DOCUMENT CHANGE REQUEST

DCR number	317	Changes required for:	N/A	Originator:	Olivier Masson Chief
Date:	2007/02/01	Date sent:	2007/02/01	Organisation:	CNES
Status:	IMPLEMENTED

Title:	Contacts Coaxial Crimp-type and Solder-Type for 3401/001 and 3401/002 Connectors		
--------	--	--	--

Number:	3401/004	Issue:	2
---------	----------	--------	---

FIGURE 2(a) – PHYSICAL DIMENSIONS (CONTINUED)

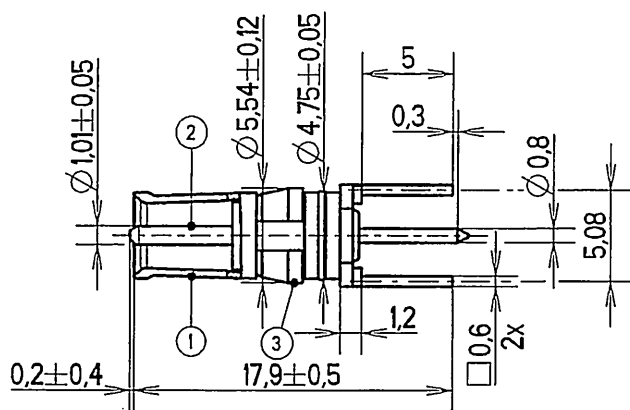
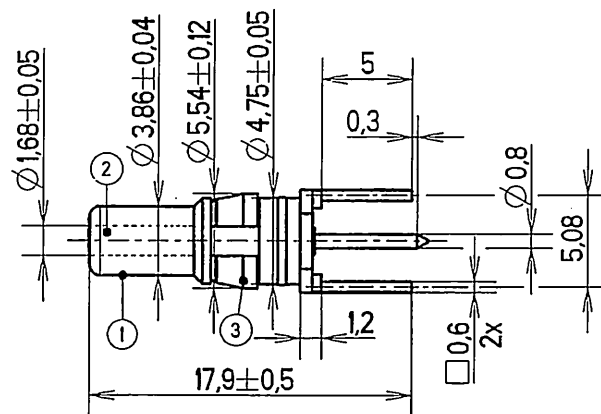
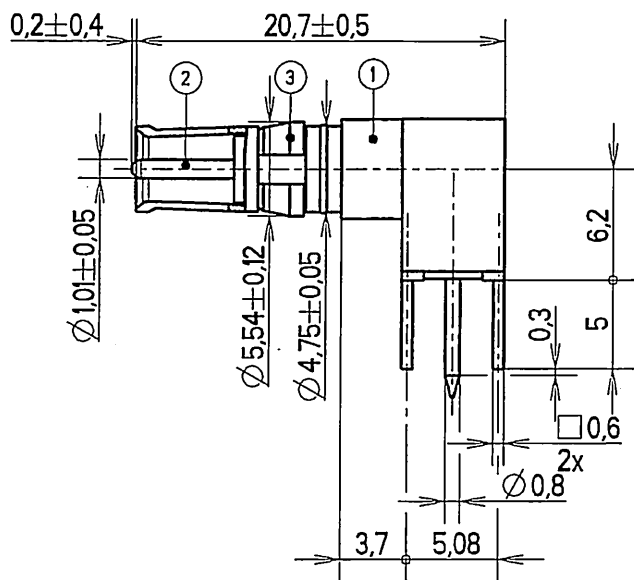
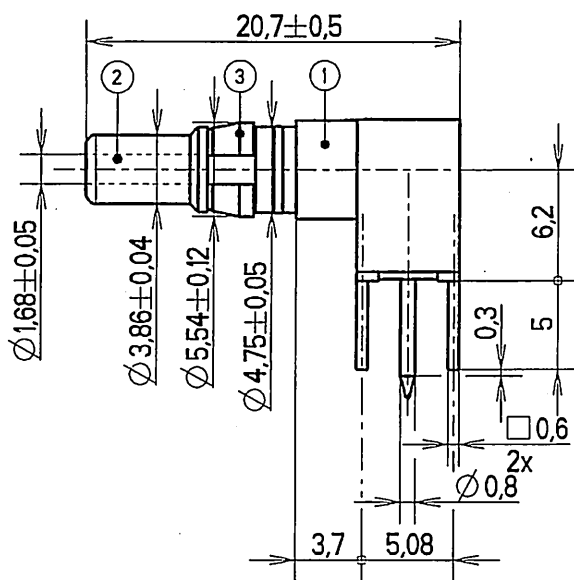
6 - Figure 2, Figures for new variants 21 to 24 added as shown in the attachment.

FIGURE 1 - PARAMETER DERATING INFORMATION

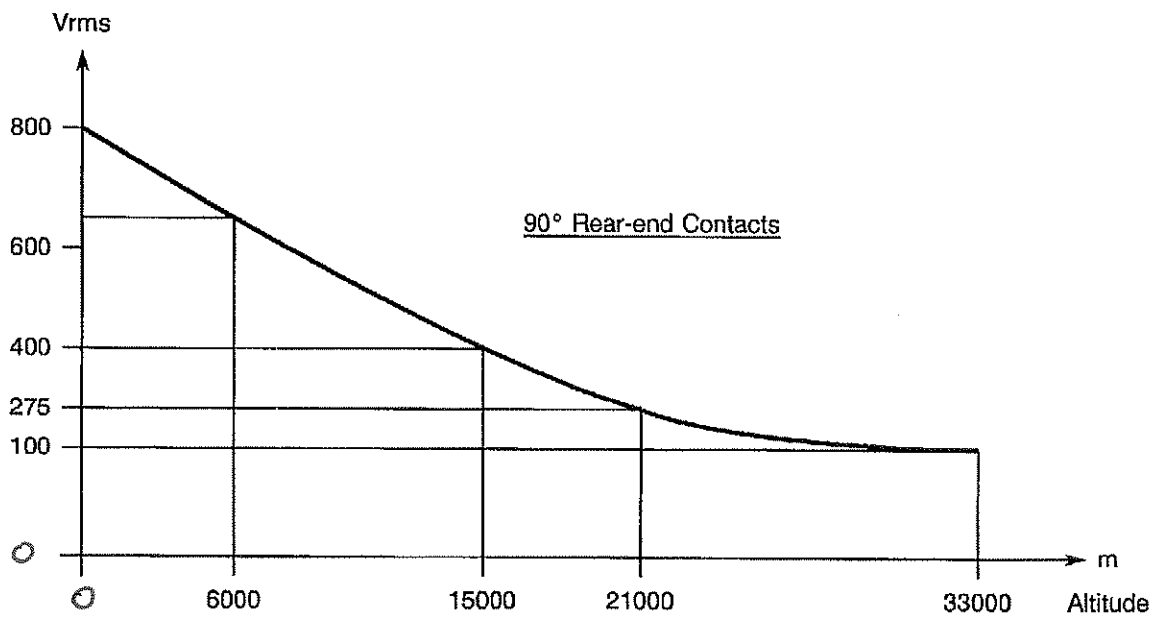
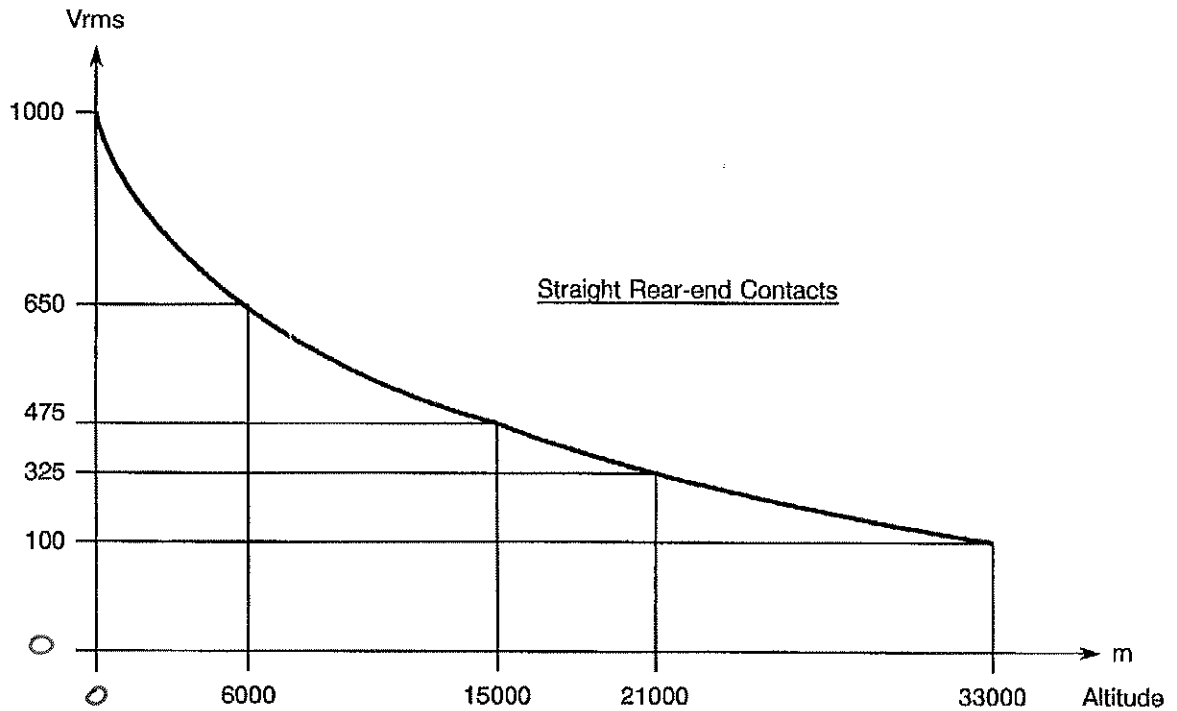
5 - Figure 1, add '0' labels to x & y axes for both figures

FIGURE 2 - PHYSICAL DIMENSIONS (CONTINUED)

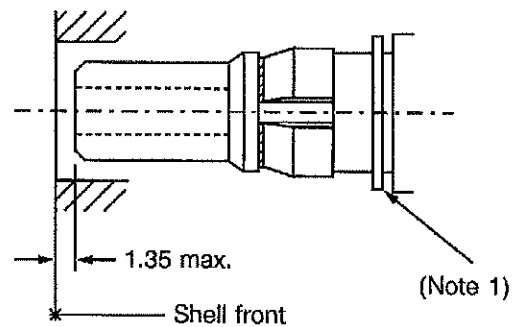
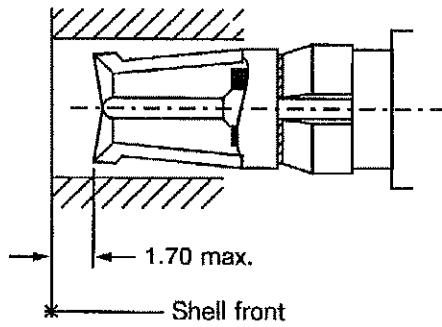
7 - Figure 2 (page 10) Maximum protrusion figure amended as shown in the attachment.

replace by
new figure
attached.

FIGURE 2 – PHYSICAL DIMENSIONS (CONTINUED)

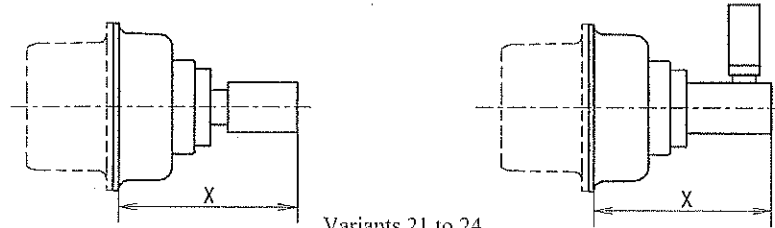
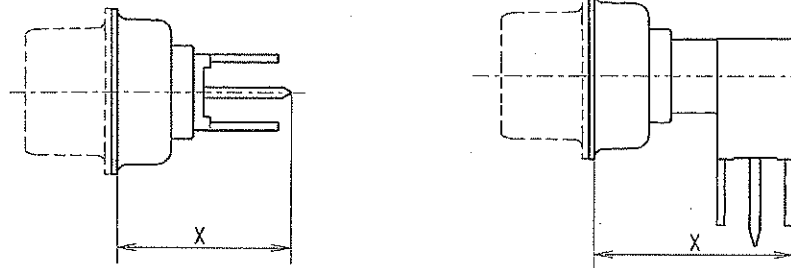
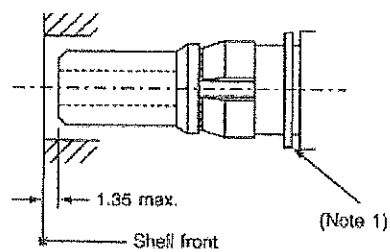
See Page ~~10~~ for value of X. → page ~~12~~ ?

Dimensions in millimetres. For lettered dimensions, see table on Page ~~10~~ → page ~~12~~ ?
